Secure 1000 Radiation Emission Measurement

FORM R-0646-1 (Single Pose)

Re: Rapiscan AIT System Radiation Survey Reporting

**R-0646-1 Addendum
(Documentation Errors)**

1. In Beam Dose Measurement: Survey Table. 1

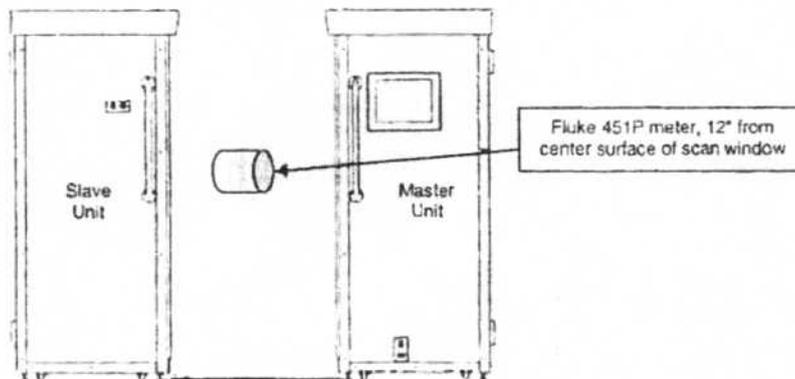
1. No value indicated for background radiation. Typical values range from 7uRem/hr to 13uRem/hr at sea level. Note: Absence of value has no adverse impact on calculations.
2. Technician indicated scan time as 7 seconds. Correct scan time is 3 seconds.
3. TABLE 1: Incorrect presentation of data in Column 3 for Measured Exposure. Indicated values are 40uR and 32uR. Corrected values are 4.0uR and 3.2uR. The values were corrected by technician when calculating Effective Dose.

The service technician should attend refresher training.

The corrected data indicates this system was operating within expected parameters. No re-survey is required for this system.
